MEMORANDUM

DATE: September 2, 2014

SUBJECT: **BZA Case 18809** - request for variance relief to operate a parking lot portion on property located at 1931 11th Street NW

Figure 1

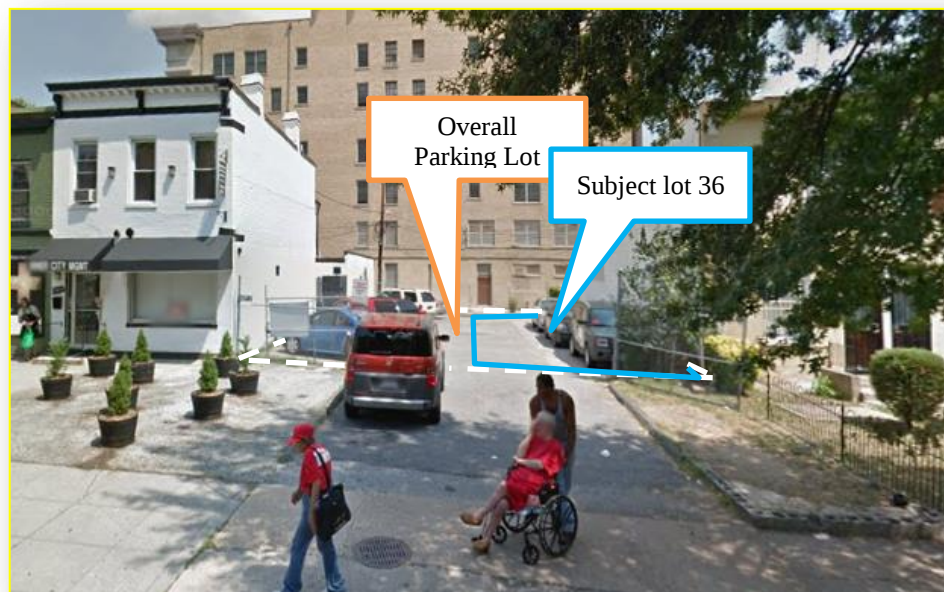
along the 11 th Street frontage along An east-west drive aisle that straddles the shared property boundary. A gated chain link fence 6-feet tall along the street and solid fence along the alley secure both properties (reference Figure 1 and Exhibit 1).
Historic District:	Greater 14 th Street
Adjacent Properties:	Two-story commercial buildings.

There is no indication that the current operation has created objectionable traffic conditions. However, the changes proposed on the annotated plat would disrupt the existing circulation through the site and possibly require a wider curb cut along 11th Street NW.

Pending the receipt of any DDOT response, this application appears to generally meet the standards for special exception approval *except* that the submitted (and overall) site plan needs to be revised to: retain the existing vehicular circulation pattern through the site; and meet the landscaping standards under § 2303.1 (f).

The Office of Planning (OP) **recommends approval** of special exception relief in accordance with § 213 subject to the submission of a workable site plan for the *entire* parking lot use on the subject lot 36 and adjacent lot 807, that conforms to § 2303.1 (f) (onsite landscaped equal to 5% of the parking lot area).

The addition of landscaping consistent with § 2303.1 (f) and replacement of the existing chain link fences along the public space is also suggested so this facility would better reflect and be more supportive of the ongoing revitalization of the U Street mixed-use corridor.
